Well Name: BRONZE MEDAL	Well Location: T23N / R10W / SEC 3 / SWNW / 36.257797 / -107.889633	County or Parish/State: SAN JUAN / NM
Well Number: 2	Type of Well: OIL WELL	Allottee or Tribe Name: EASTERN NAVAJO
Lease Number: N00C14207307	Unit or CA Name:	Unit or CA Number:
US Well Number: 300452692500S1	Well Status: Producing Oil Well	Operator: DUGAN PRODUCTION CORPORATION

Notice of Intent

Type of Action: Plug and Abandonment

CONDITIONS OF APPROVAL

Current Wellbore Schematic

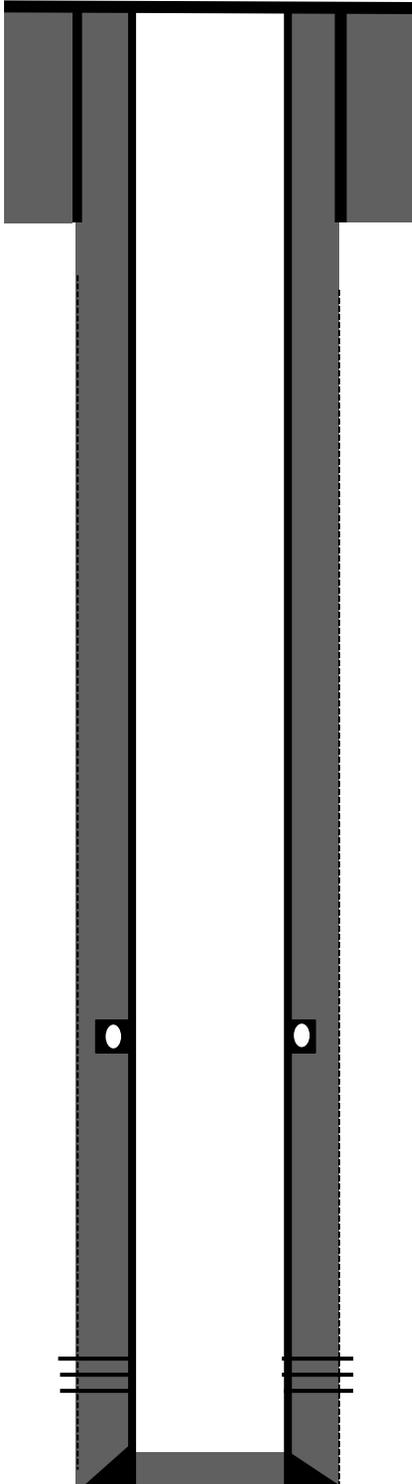
1. Plugging operations authorized are subject to the attached "General Requirements for Permanent Abandonment of Wells on Federal and Indian Lease."
2. The following modifications to your plugging program are to be made:
 - a. Add cement so that the top of cement for Plug III is 50 feet above the BLM pick for the Chacra at 1500'.
3. Farmington Office is to be notified at least 24 hours before the plugging operations commence at (505) 564-7750.

-- Raster log data confirms the formation tops provided by the operator. Except for the Chacra formation top. The Dual Induction/ Short Guard raster log indicates the formation top to be at a depth of 1500 feet. Additional cement coverage should be added so that top of cement of Plug III is 50 feet above this pick for the Chacra formation.
